**P22-19**  
**Hotel Redevelopment**  
**REVISED**

Property Owner: Legacy Hotel of Medina LLC  
Applicant: Jim Gerspacher  
Location: 257 South Court Street  
Zoning: C-2 (Central Business)  
Request: Revised Site Plan approval for the construction of a hotel

The current application requests modifications to the southeast corner of the building by incorporating a door on the east side of the building, a door on the south side of the building, and a new staircase.

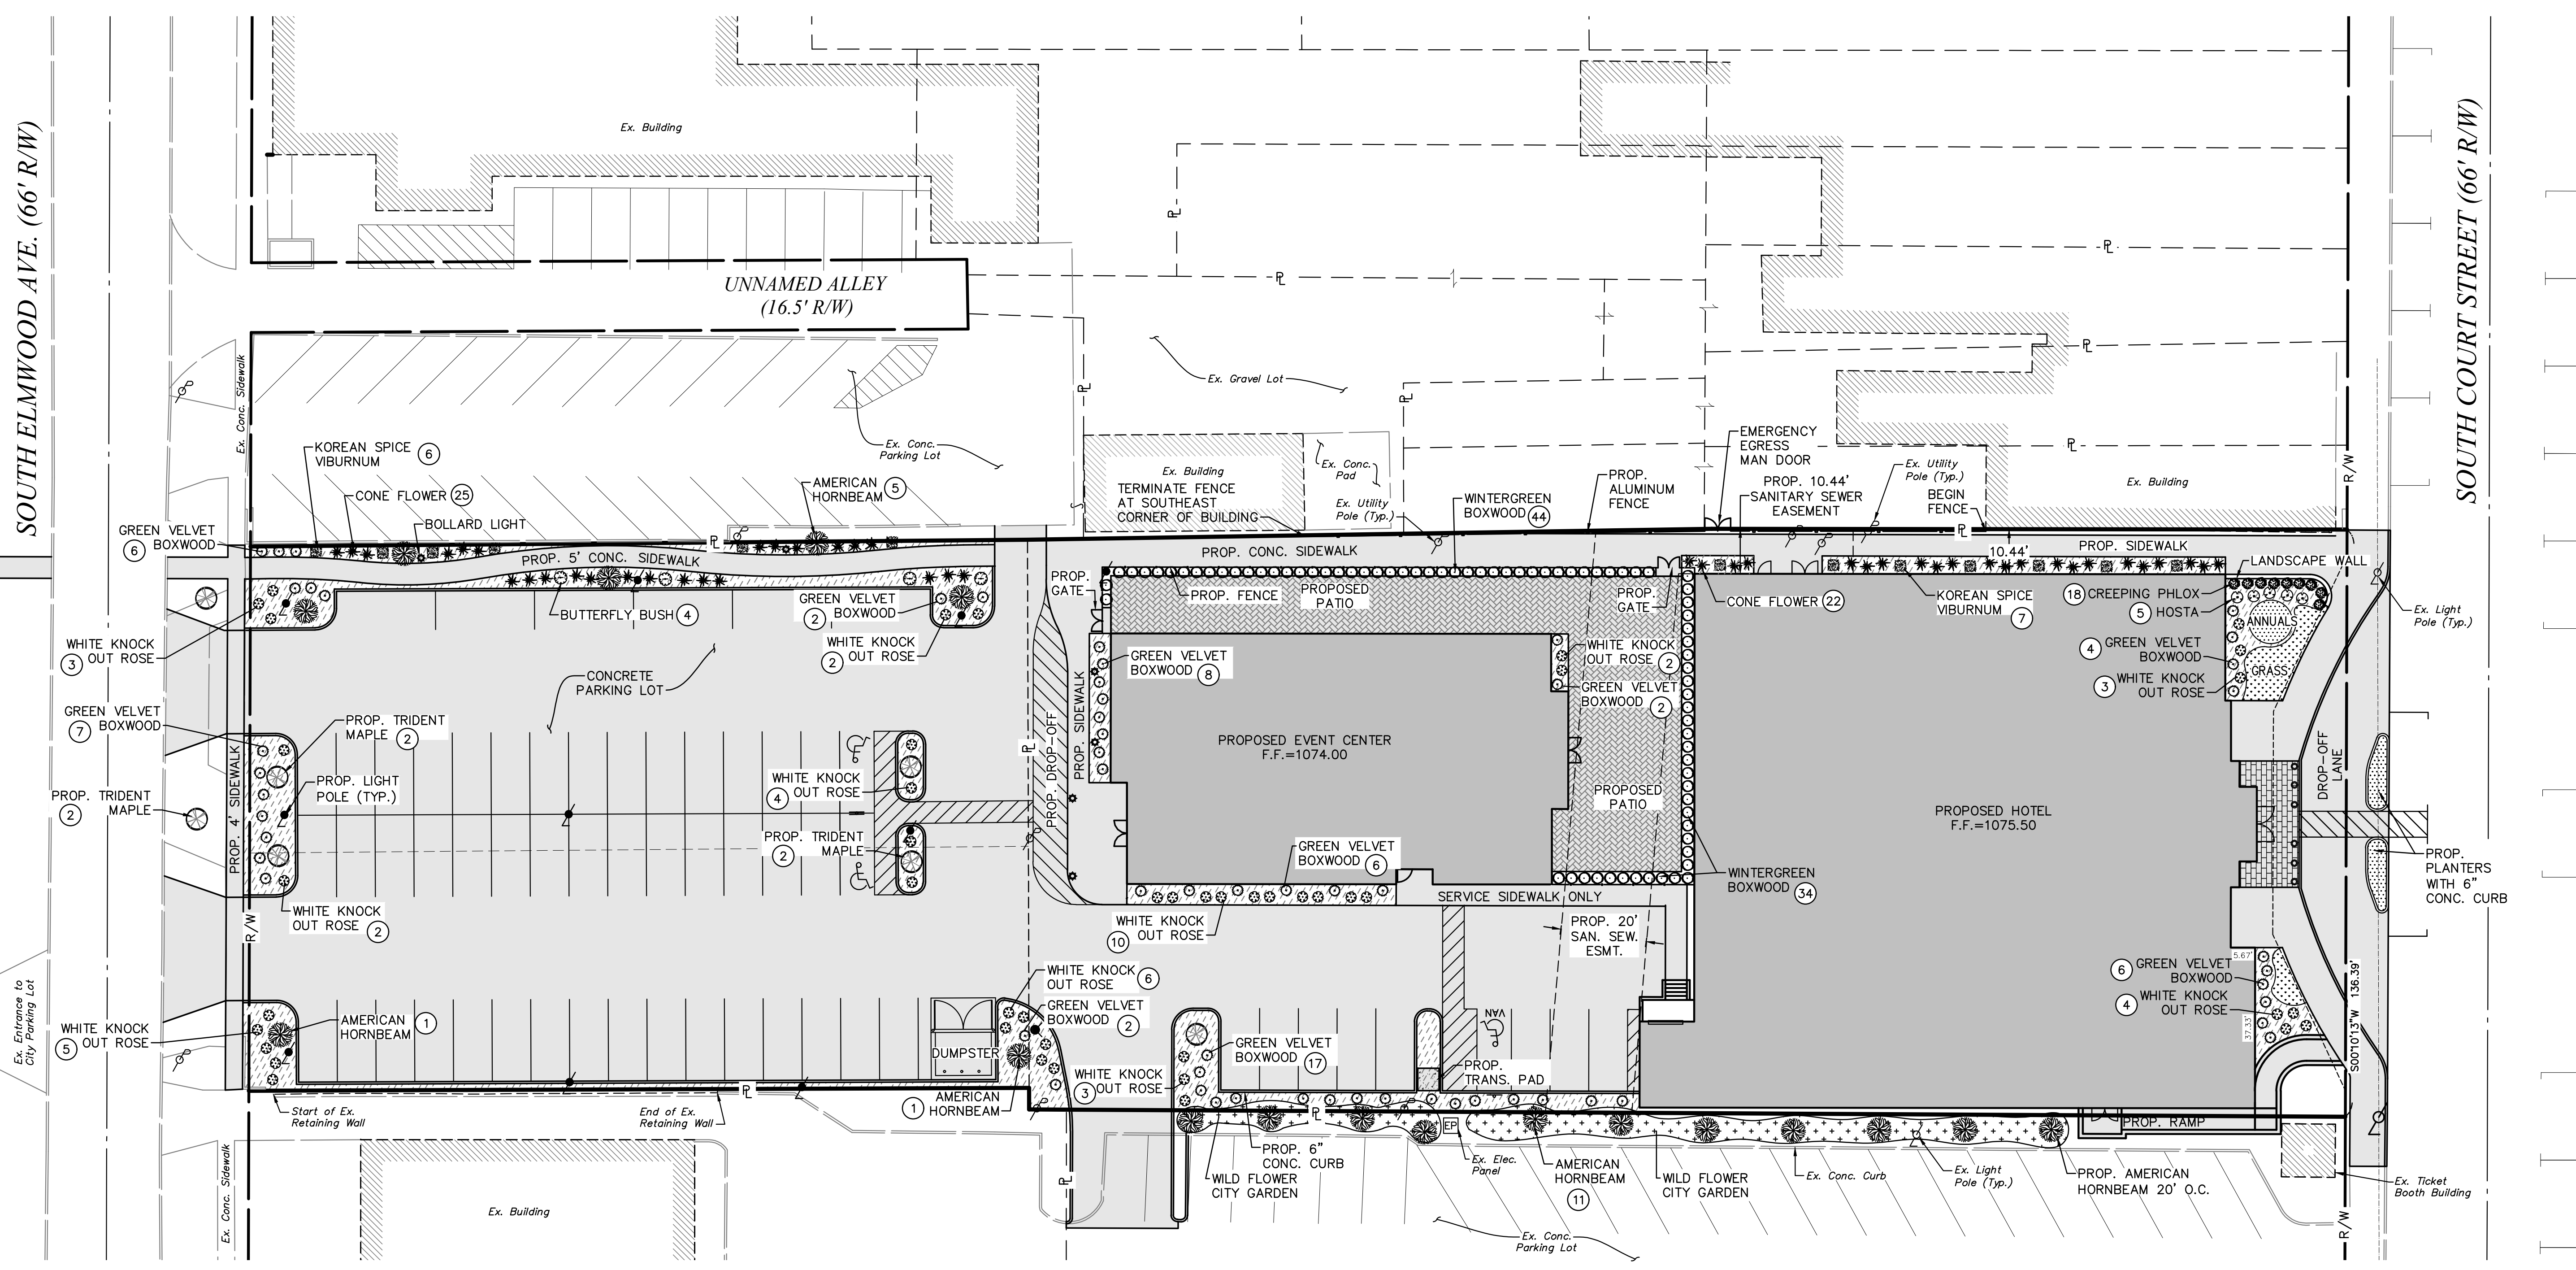
### **Site (Southeast Corner)**

#### Approved 5/9/24

- Landscaping between the hotel and the sidewalk
- A ramp/walkway connecting the sidewalk to an entrance on the south side of the building, incorporating a black metal railing, and partially located on the Feckley Lot property

#### Proposed

- A hardscaped area with steps, a patio area, and potted plants south of the main entrance between the hotel and the sidewalk
- The connection of the ramp/walkway to the Feckley Lot via the aforementioned stairs
- A hatched area in one or more parking spaces in the Feckley Lot

The acceptance of hatching of an existing parking space(s) in the Feckley Lot would be included in Condition #4 of the previous approval, which states: "Use, improvements, or access to the public right-of-way or City Parking Lot #4 shall be authorized in a format determined by the City Law Director".
